Access Compliance Report

Public Rights-of-Way

(Curb Ramps)

Intersection ID: 47226	Main Street: OAKSHIRE_CR	Cross Street: VALLEYDALE_RD	Location:	N
ADA ID: D6A01B099E0D	Ramp Type: PerpDiag	Initial Pass/Fail: Fail	Overall Compliance: No	Severity Score: 12.5
Codes/Mitigation Info/Possible Solution		Field Measurements/Component Compliance

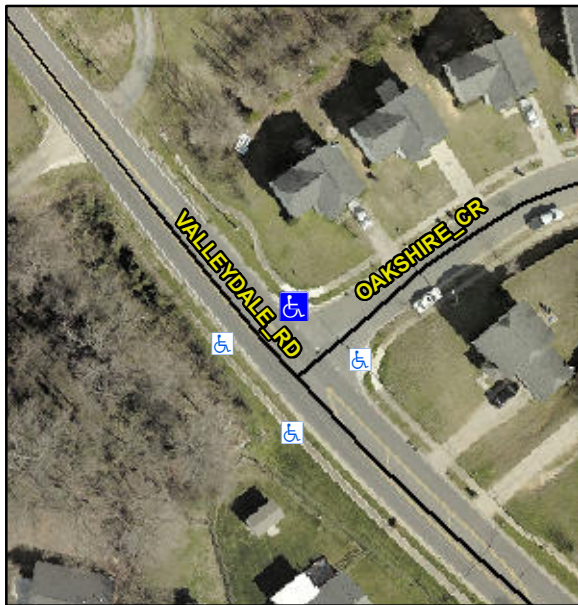
Not Found, R304.2.2

Compliance	Description	Data	Compliance	Description	Data
N/A	Ramp Length (in)	48.0	No	Ramp Slope (%)	10.3
Yes	Ramp Width (in)	53.5	Yes	Ramp XSlope (%)	1.3
N/A	Flare Type LT	N/A	N/A	Flare Type RT	N/A
N/A	Flare Slope LT (%)	N/A	N/A	Flare Slope RT (%)	N/A
N/A	Flare Traversable LT?	N/A	N/A	Flare Traversable RT?	N/A
N/A	Landing Length (in)	N/A	N/A	DWS Provided?	N/A
N/A	Landing Width (in)	N/A	N/A	DWS Contrast?	N/A
N/A	Landing Slope (%)	N/A	N/A	DWS Length (in)	N/A
N/A	Landing X Slope (%)	N/A	N/A	DWS Full Width?	N/A
N/A	Landing Curb? (Y/N)	N/A	N/A	DWS Offset (in)	N/A
N/A	Shared Landing?	N/A			
N/A	Gutter Ponding?	N/A	N/A	Gutter Slope (%)	N/A
N/A	Gutter Lip Ht (in)	1.0	N/A	Gutter X Slope (%)	N/A
N/A	Painted X Walk1?	No	N/A	Painted X Walk2?	No
	X Walk 1 Direction	To SW		X Walk 2 Direction	To SE
N/A	X Walk 1 Width (in)	N/A	N/A	X Walk 2 Width (in)	N/A
	X Walk 1 Slope (%)	9.4		X Walk 2 Slope (%)	4.4
	X Walk 1 X Slope (%)	2.7		X Walk 2 X Slope (%)	2.8

Remove & Replace Curb Ramp With Two New Directional Ramps or Equivalent.
